Paramount Resources Ltd.

Significant Discovery Licence 8, 2D Geophysical Program

Environmental Assessment EA0506-007

Developers Assessment Report

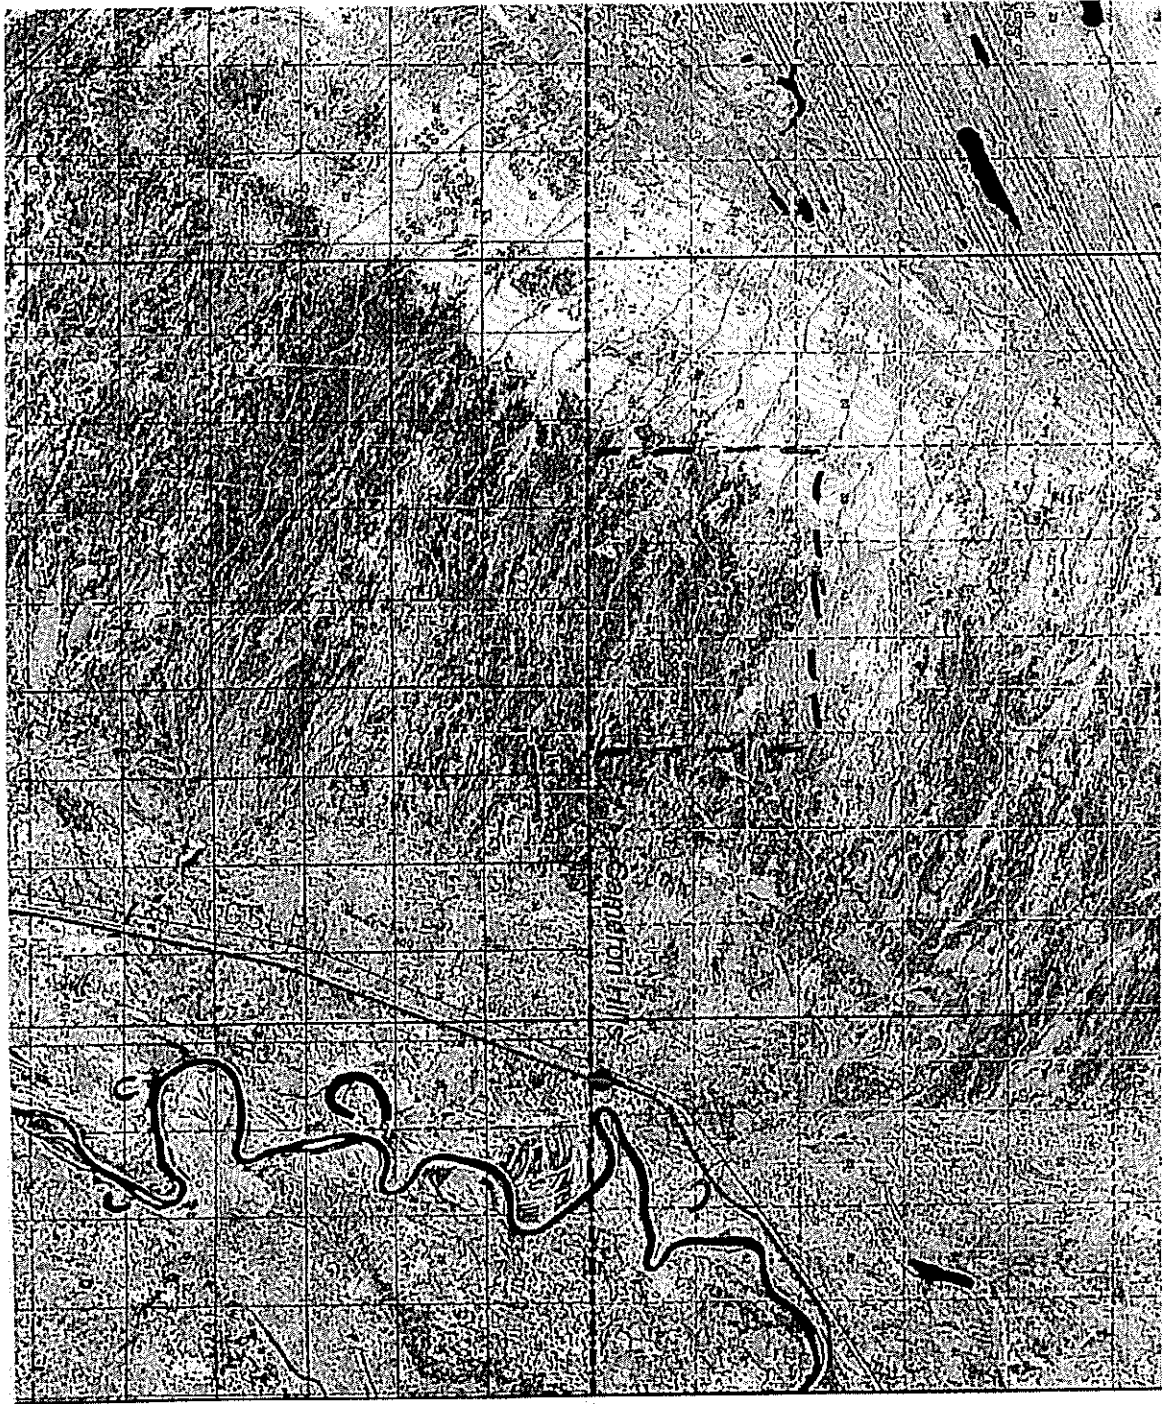
- 3) *Please predict the combined effects of the developments identified in (2) on the Valued Components identified in (1). Your prediction should include but not be limited to the following:*
- a. *Potential effects to the Valued Components of the environment likely to result from the proposed development in combination with past, present or reasonably foreseeable developments; and*
 - b. *The contribution of the SDL8 development to these larger cumulative effects.*

As the proposed seismic program is limited in scope and timing, Paramount predicts the impacts of its activities to also be limited in scope.
